Planning Delegated Committee Meeting

6.1. PLP/2020/262 - 107 DOVETON STREET SOUTH BALLARAT

1. For Council to consider a planning application for use and development of a residential hotel, alteration of access to a road in a Transport Zone 2, sale and consumption of liquor (Restaurant and Café Licence) in association with a café (as of right), variation to an easement and associated reduction in car parking requirements.

3. The plans that form part of the basis of Council’s consideration were prepared by apt architecture Pty Ltd and are known as Project No. 17046, Drawing Nos. TP04 through to TP13 and advertised in December 2021.

DRAWN	TY	SCALE	DRAWING NO.
CHECKED	MP	1:100 A2	TP 04
DATE	JULY 2021	PROJECT No	REV
TOWN PLANNING		17046	2
NOT FOR CONSTRUCTION

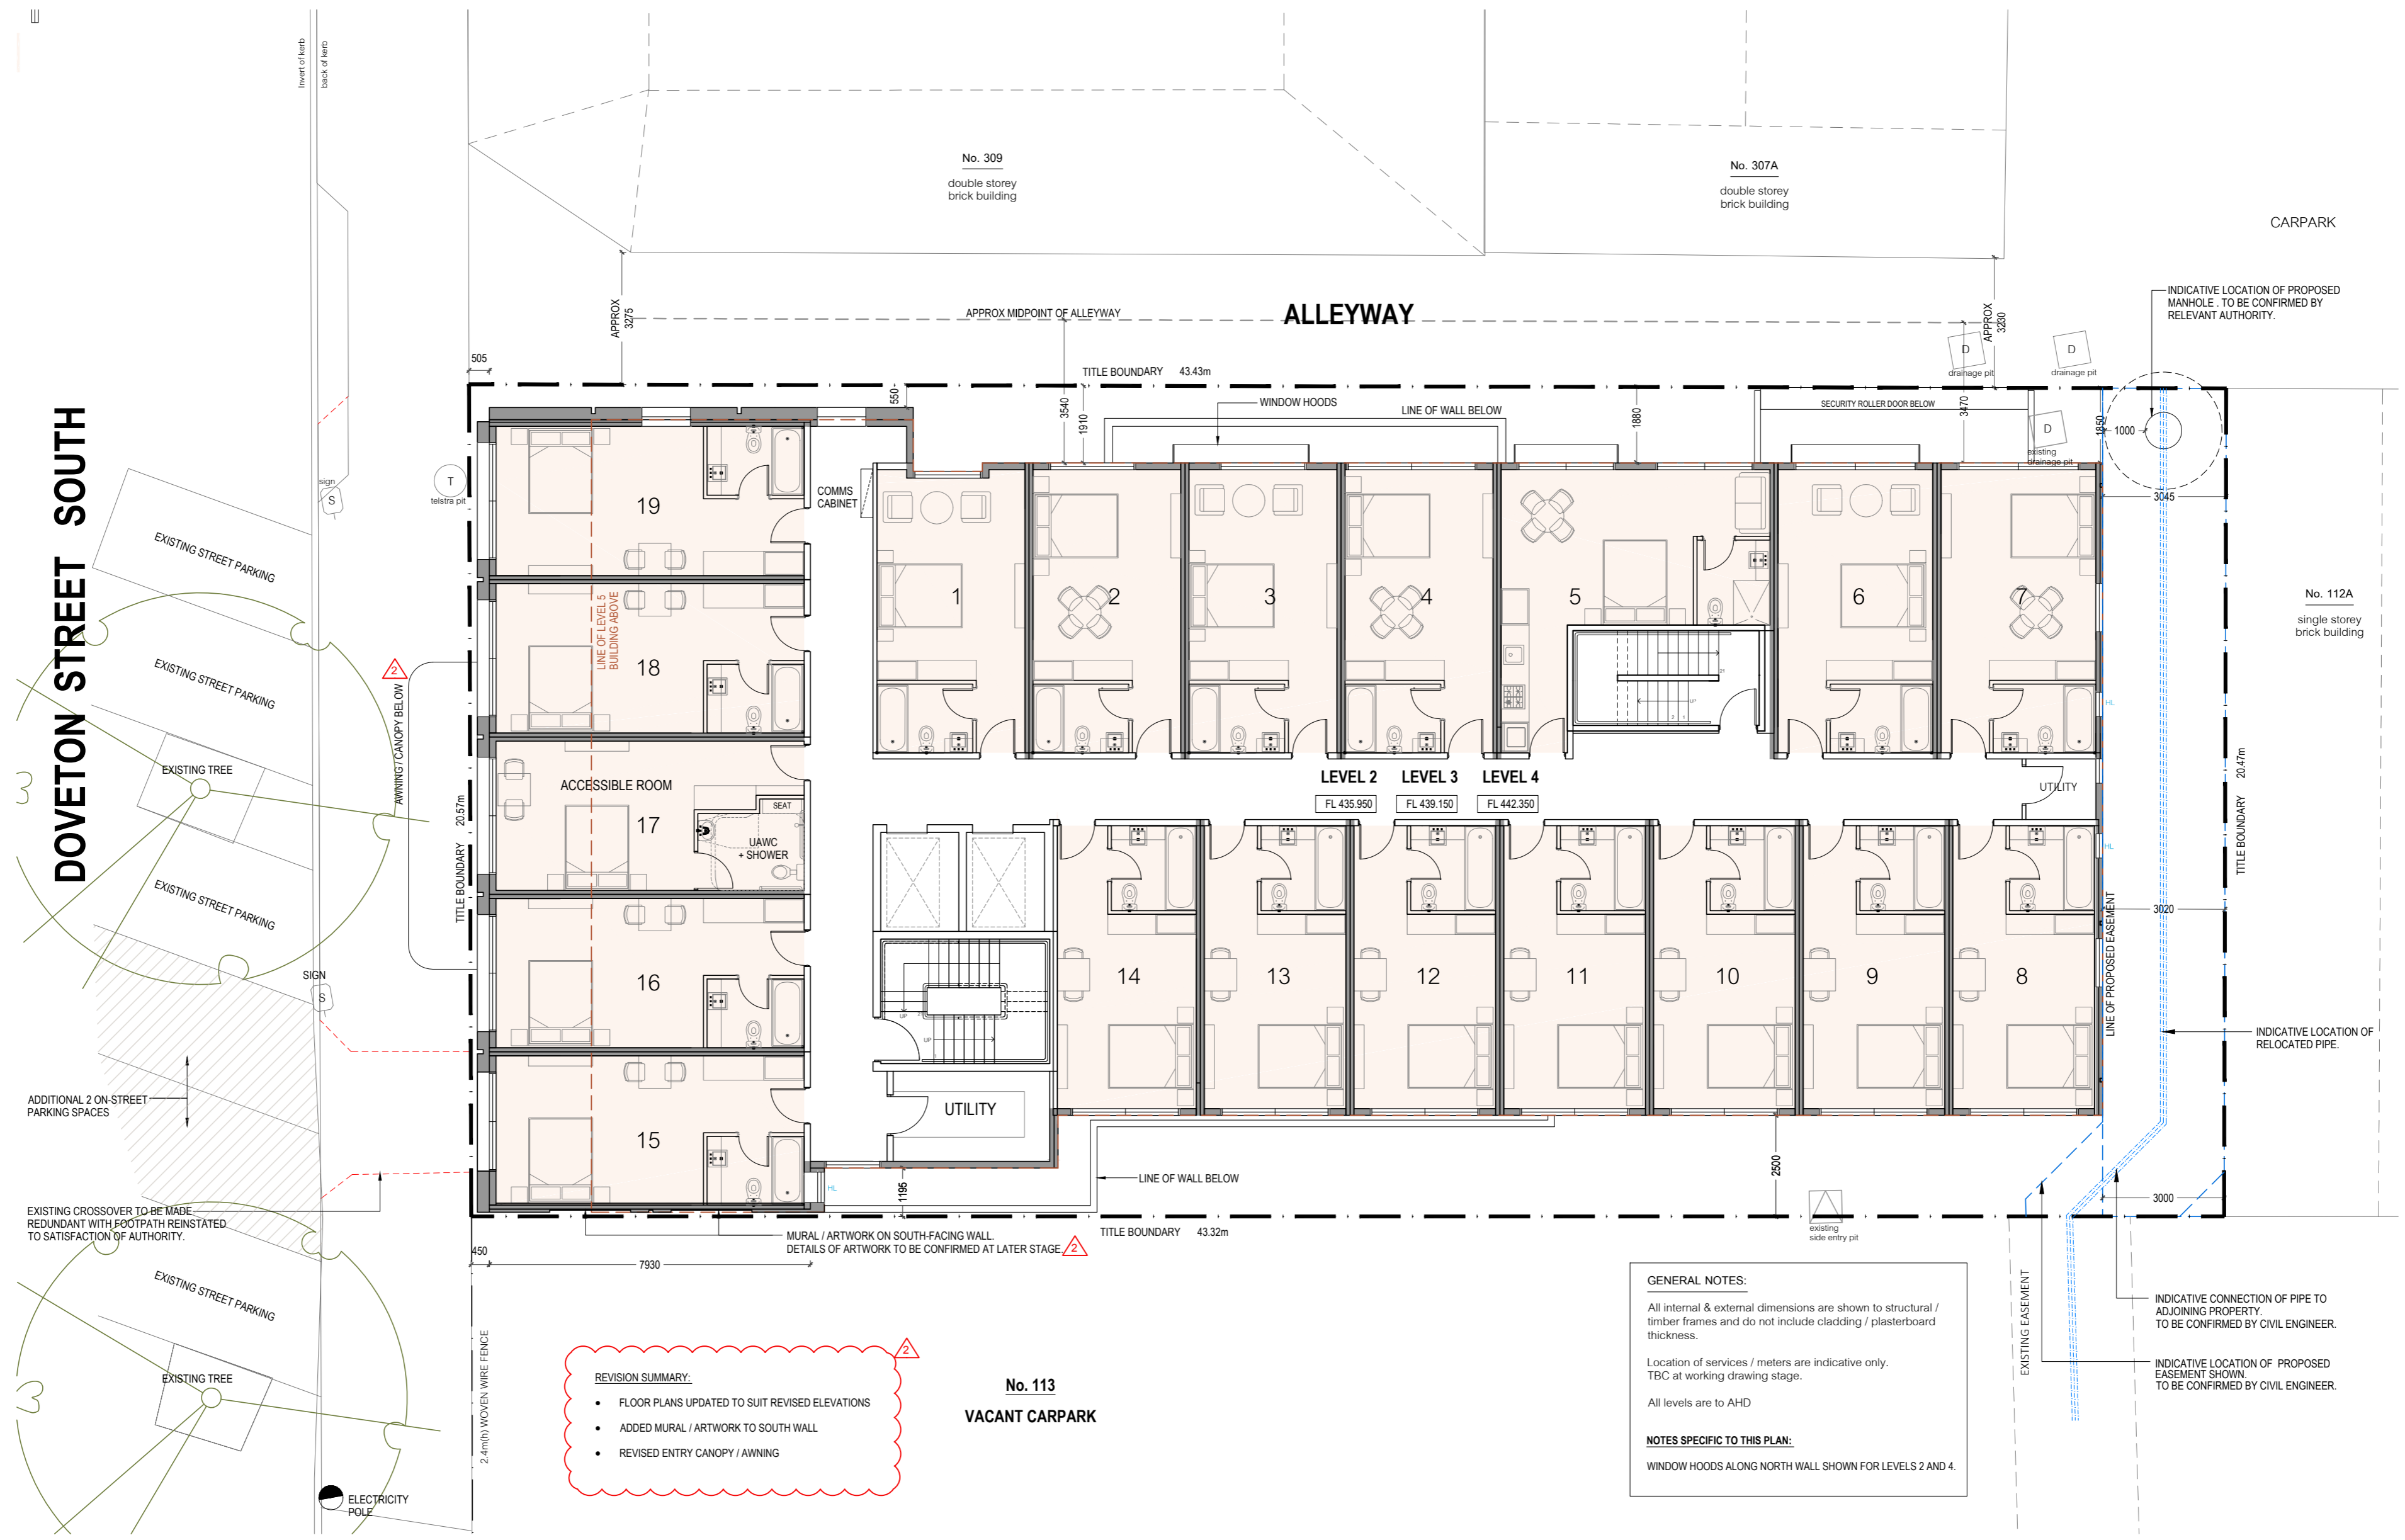
- FLOOR PLANS UPDATED TO SUIT REVISED ELEVATIONS
- ADDED MURAL / ARTWORK TO SOUTH WALL
- REVISED ENTRY CANOPY / AWNING
- PASSING BAY NOTED TO BE CARRIAGEWAY EASEMENT.

DRAWN	TY	SCALE	DRAWING NO.
CHECKED	MP	1:100 A2	TP 06
DATE	JUNE 2021	PROJECT No	REV
TOWN PLANNING NOT FOR CONSTRUCTION		17046	2

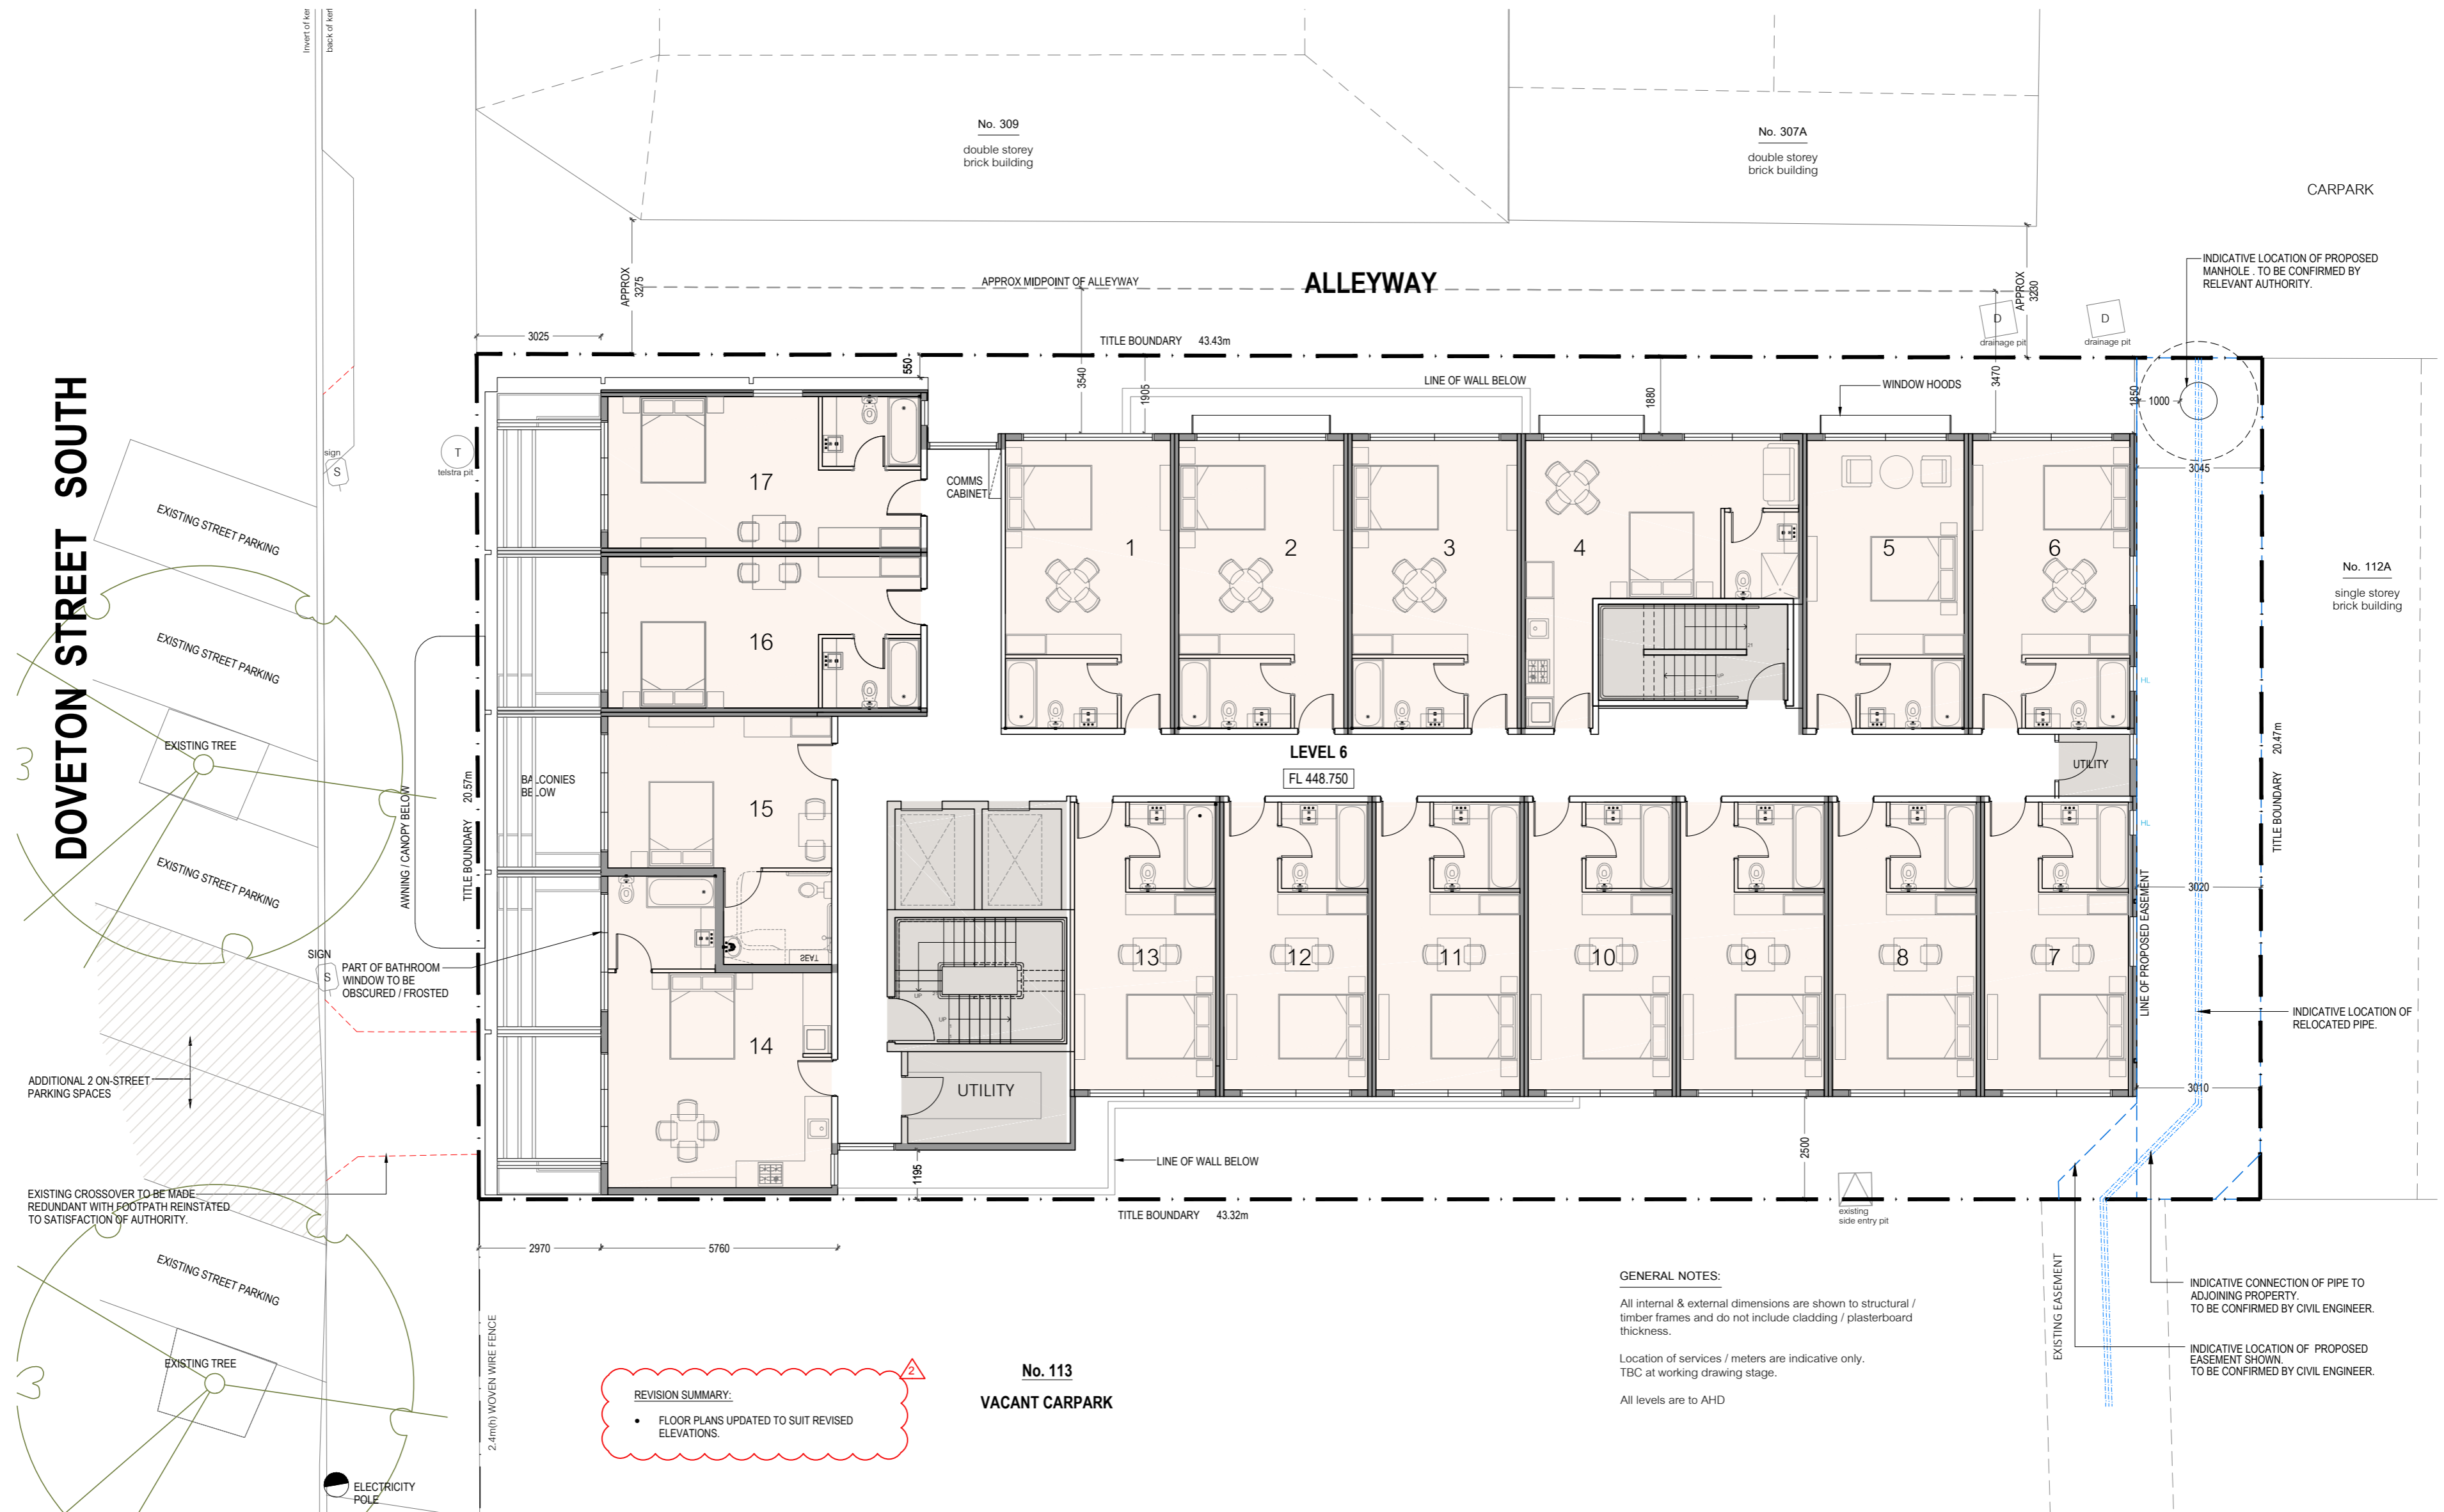
- FLOOR PLANS UPDATED TO SUIT REVISED ELEVATIONS
- ADDED PERGOLAS TO BALCONIES

DRAWN	TY	SCALE	DRAWING NO.
CHECKED	MP	1:100 A2	TP 10
DATE	JULY 2021	PROJECT No	REV
TOWN PLANNING NOT FOR CONSTRUCTION		17046	2

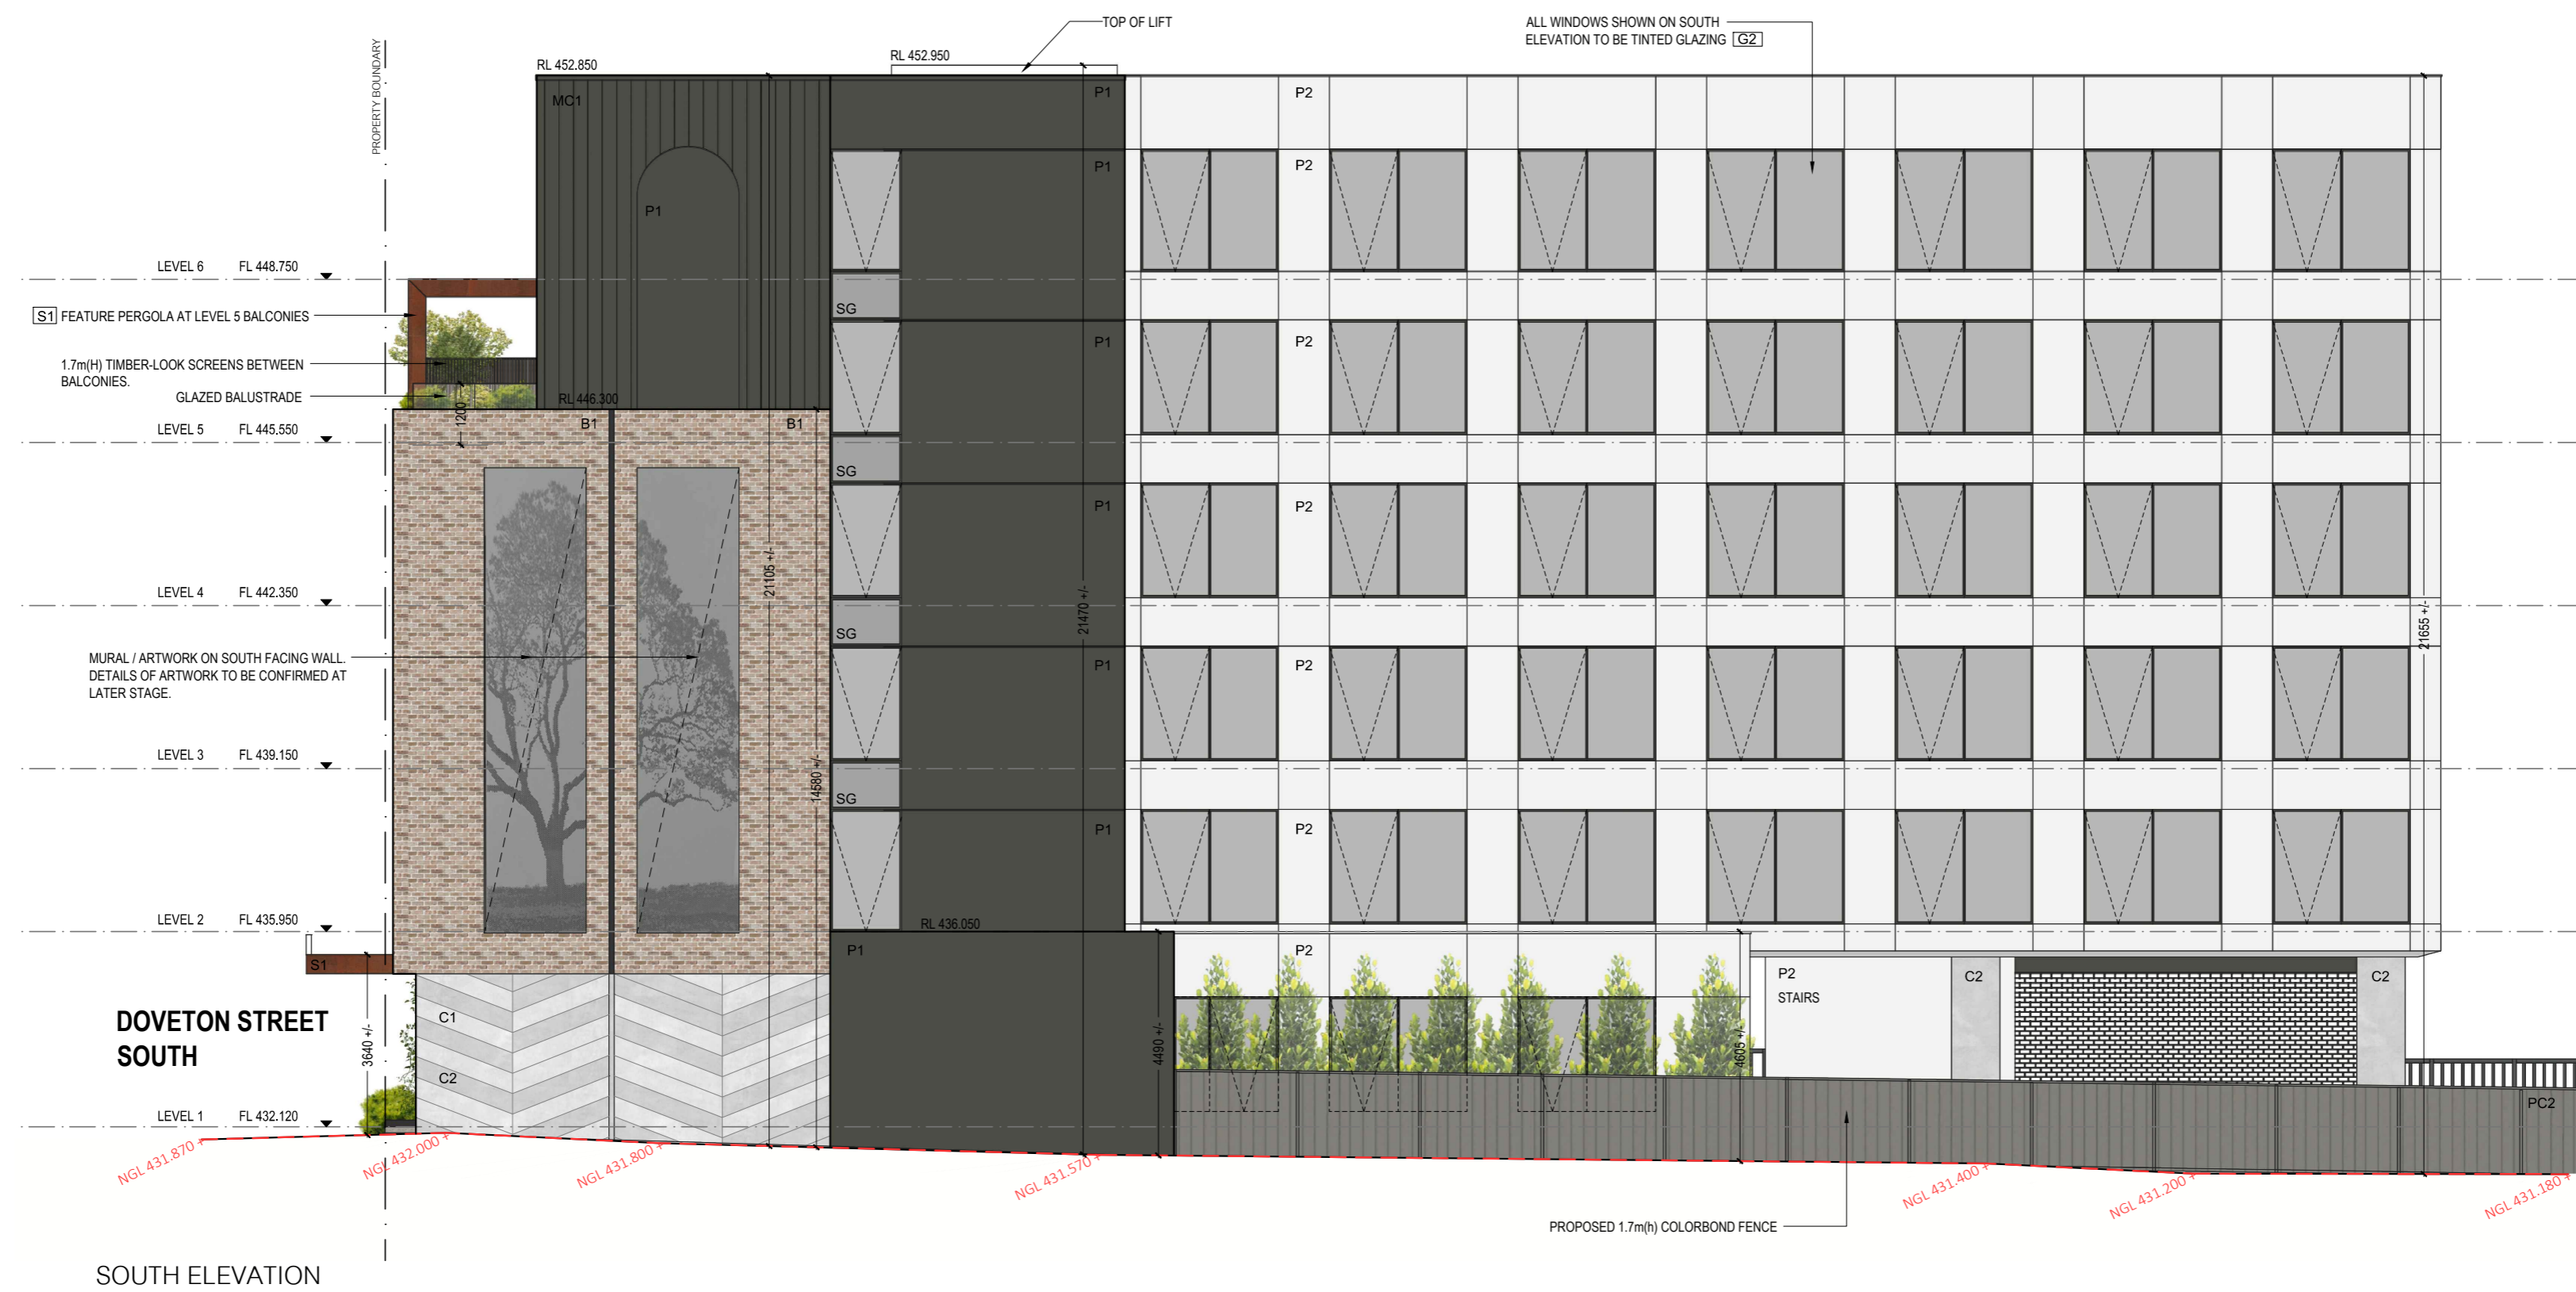
- ELEVATIONS DESIGN AND FINISHES UPDATED.
- ADDED PERGOLA TO BALCONIES
- ADDED MURAL / ARTWORK TO SOUTH WALL
- REVISED ENTRY CANOPY / AWNING
